Penn Reel Parts list for:

Model: PUR5000 Pursuit Spinning Series

MYSTIC REEL PARTS REVISION!

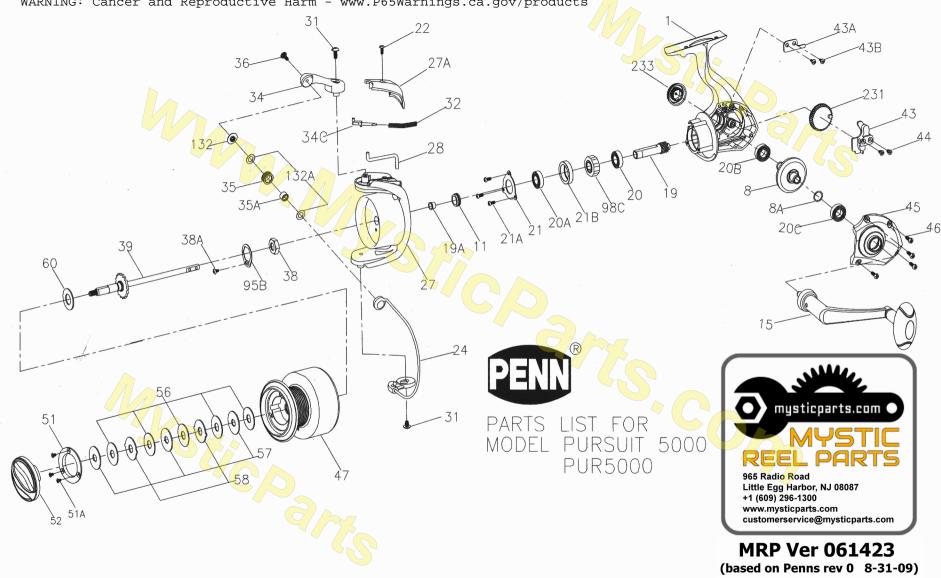
DESIGN CHANGE TO SHAFT / DRAG KNOB

https://www.mysticparts.com/PennParts/Pursuit-Reels-Design-Change.aspx							
39	1204051	39-5000PUR Shaft, Spool Shaft (FINE Thread) (PUR5000)						
52	1204058	52-5000PUR Knob, Drag Knob Assembly (TWO Thread Types) (PUR5000, FINE)						
39	1191753	39-5000SG Shaft, Spool Shaft (COARSE Thread) (SG5000)						
52	N/A	52-5000PUR Knob, Drag Knob Assembly (TWO Thread Types) (PUR5000, COARSE) **NOT AVAILABLE **

ROLLER BUSING REPLACEMENT NOTES

35A 1203992 35A-3000PUR LINE ROLLER BUSHING

The single 35A-3000PUR is no longer available

It can be replaced with TWO of the 35A-SLAiii3500 bushings

1474155 35A-SLAiii3500 LINE ROLLER BUSHING (2 REQUIRED)

This applies to all 1st Gen PUR3000 through PUR8000 reels
